## Planning and Zoning Commission

**CITY OF FAIRBURN  
PLANNING AND ZONING COMMISSION  
AGENDA ITEM**

Date: May 4, 2021  
To: Planning and Zoning Commission  
From: Tarika Peeks, Director of Planning Zoning  
Agenda Item: Conceptual Plat 2021062 –Trinity Fairburn: A request to subdivide a 9.511 acre parcel into three (3) tracts.

Date: May 4, 2021  
To: Planning and Zoning Commission  
From: Tarika Peeks, Director of Planning Zoning  
Agenda Item: Conceptual Site Plan 2021057 - Tractor Supply: A request to construct a 22,136 square-foot commercial building for a Tractor Supply store.

OVERALL SITE & PAVING PLAN

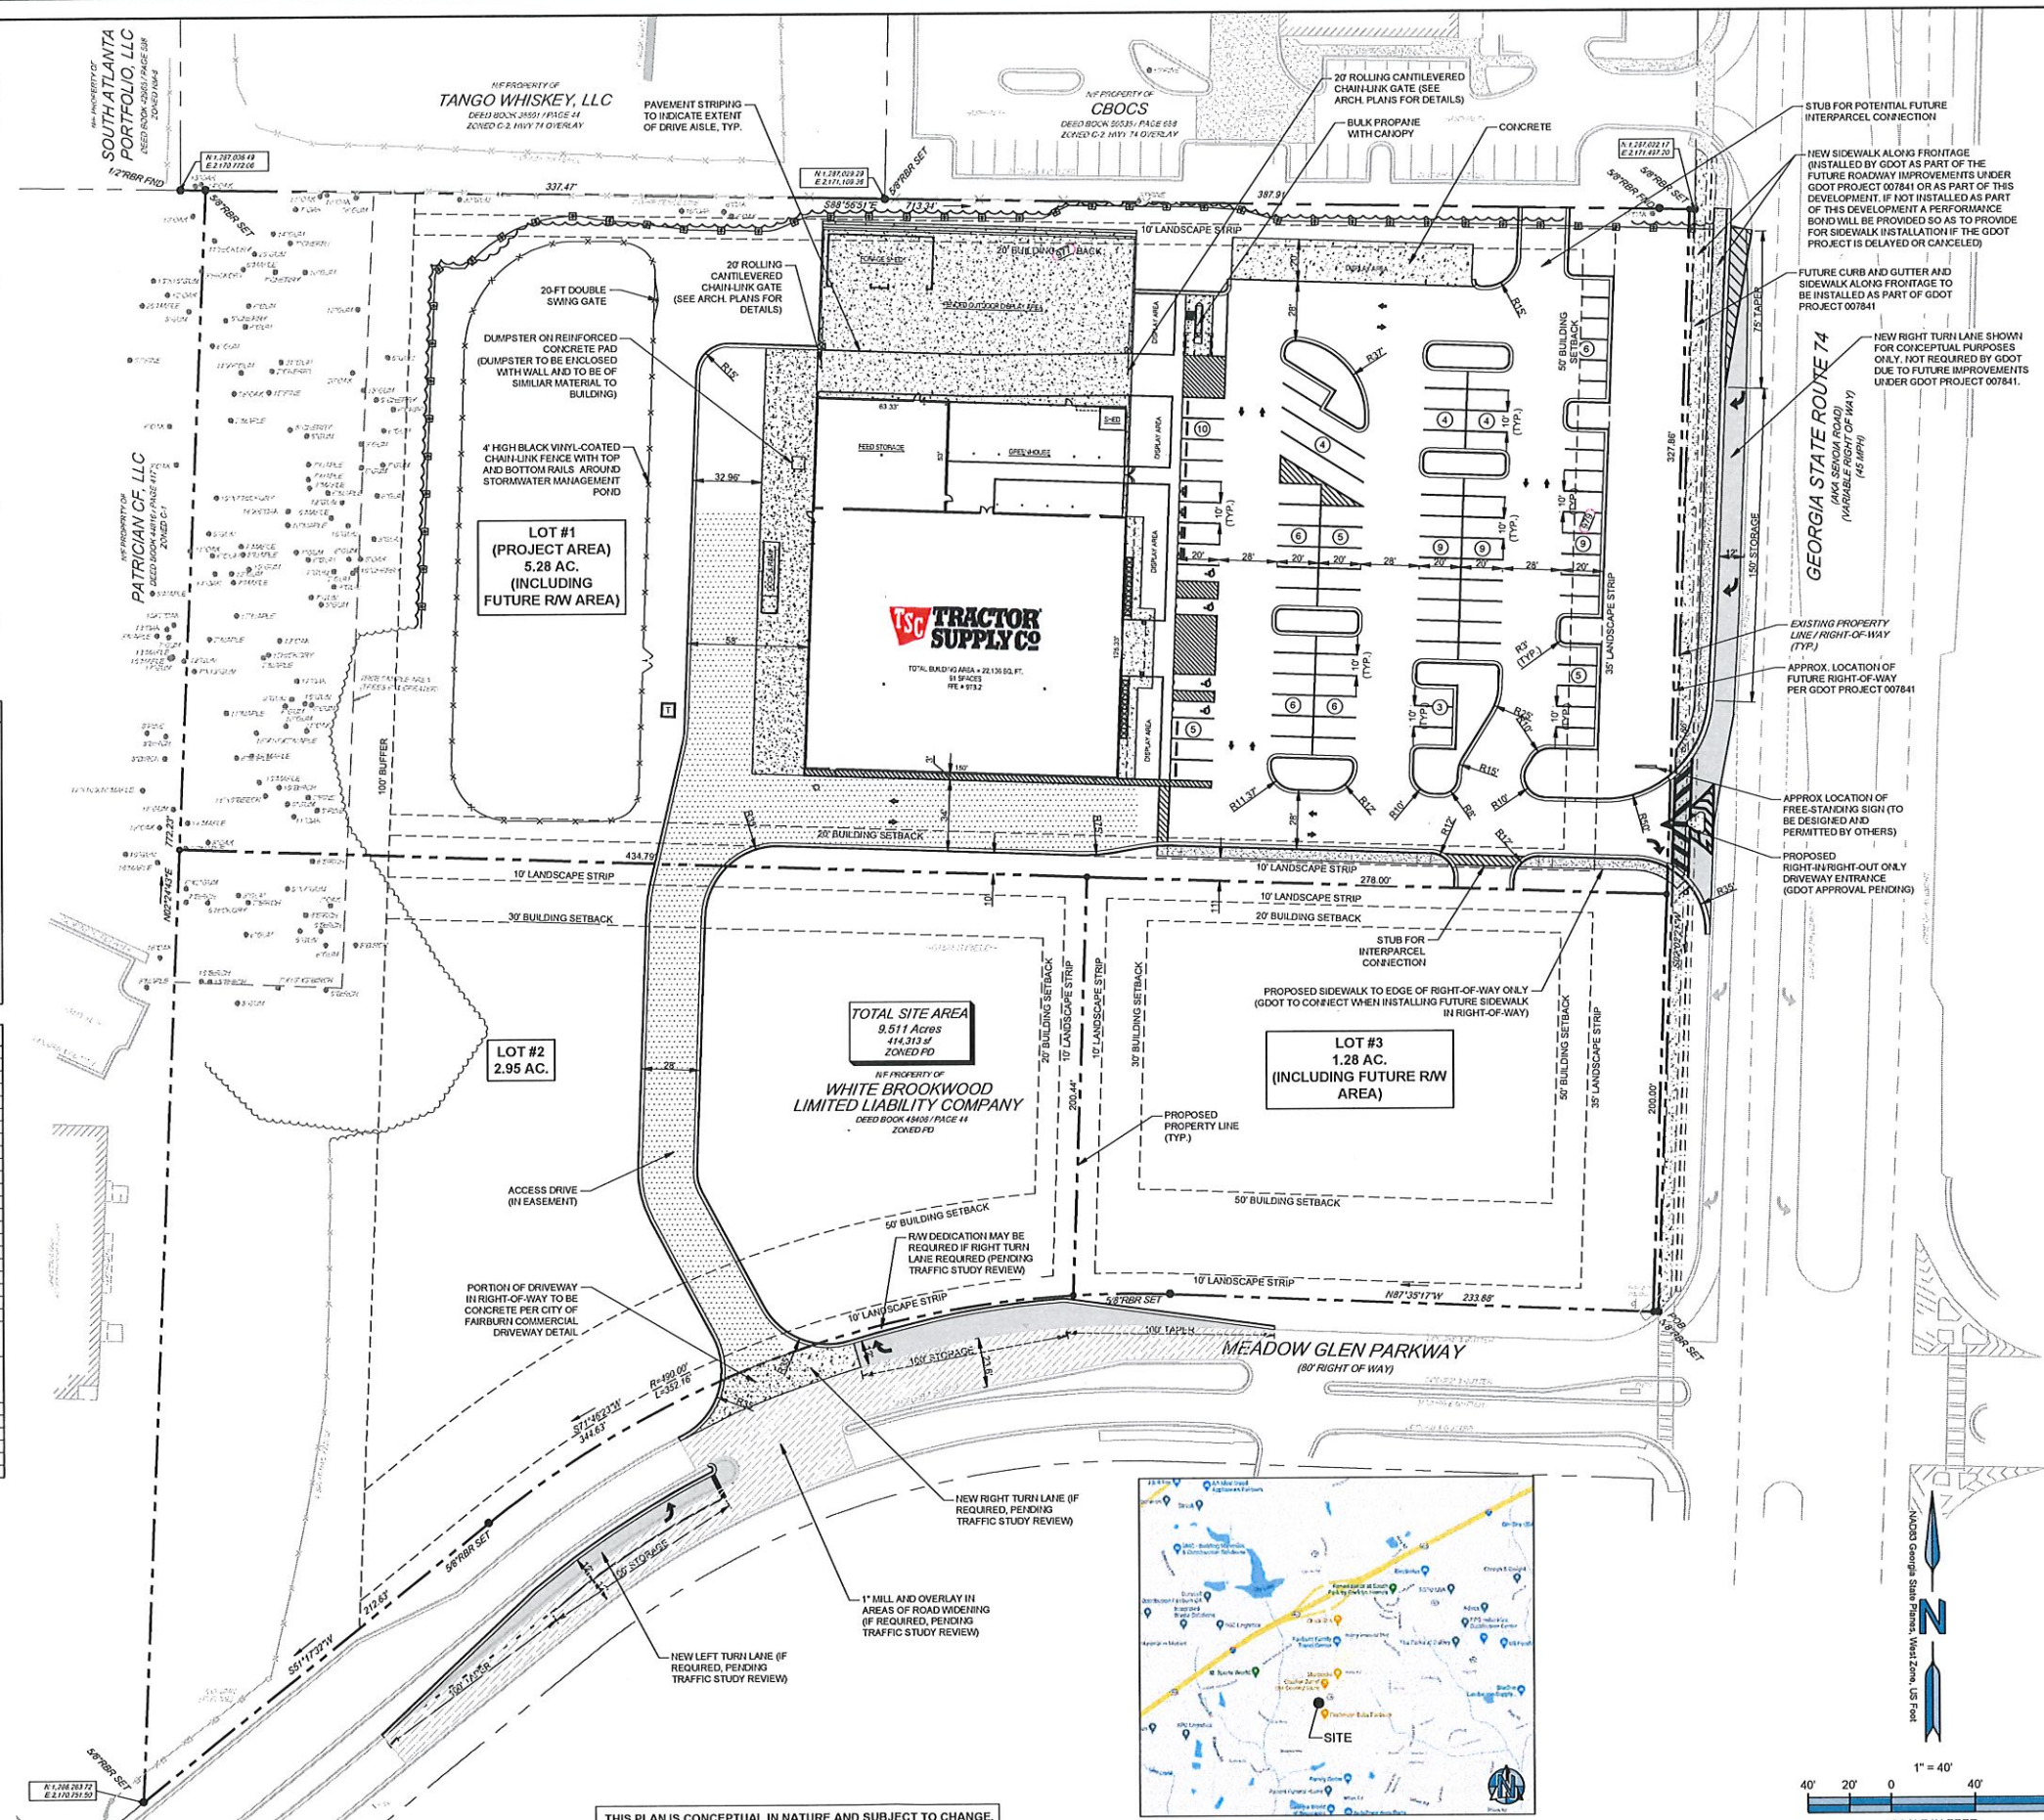
**STAFF RECOMMENDATION:** APPROVAL CONDITIONAL of the conceptual site plan to construct a 22,136 square-foot building for a Tractor Supply retail store. The staff has reviewed the conceptual site plan and has determined that the plan met the requirements for a conceptual review. The staff has recommended five (5) conditions.

The approval of the site plan is conceptual only. The applicant will be required to submit a Land Disturbance Permit prior to the start of any construction. Additionally, any significant changes as determined by staff to the approved conceptual plan would warrant a further review by the Planning and Zoning Commission.

1. To the site plan submitted to the Department of Community Development dated received April 28, 2021. Said site plan is conceptual only and must meet or exceed the requirements of the City's regulations and ordinances prior to the approval of a Land Disturbance Permit. Unless otherwise noted herein, compliance with all conditions shall be in place prior to the issuance of a Certificate of Occupancy. Any major deviation from this site plan is subject to approval by the Planning and Zoning Director or designee.

2. Prior to construction, the city shall be provided with copies of the approved agreements/easements between all involved parties/owners for the driveway; inter-parcel access ways, and sidewalks. All plans for road improvements shall be submitted, reviewed, and approved by the City Engineer and GDOT, if applicable; and appropriate permits issued prior to construction and authorization.

3. No outside storage or outside display of merchandise shall be located in the 35' landscape strip fronting Highway 74/Senoia Road.
4. The designated outside display areas as shown on the conceptual site plan dated April 28, 2021, shall be kept neat, clean, and well-maintained.

5. The outside display of merchandise shall not exceed the boundaries of the areas designated for outside display as shown on the conceptual site plan dated April 28, 2021; no display of merchandise shall be placed in the off-street parking area.
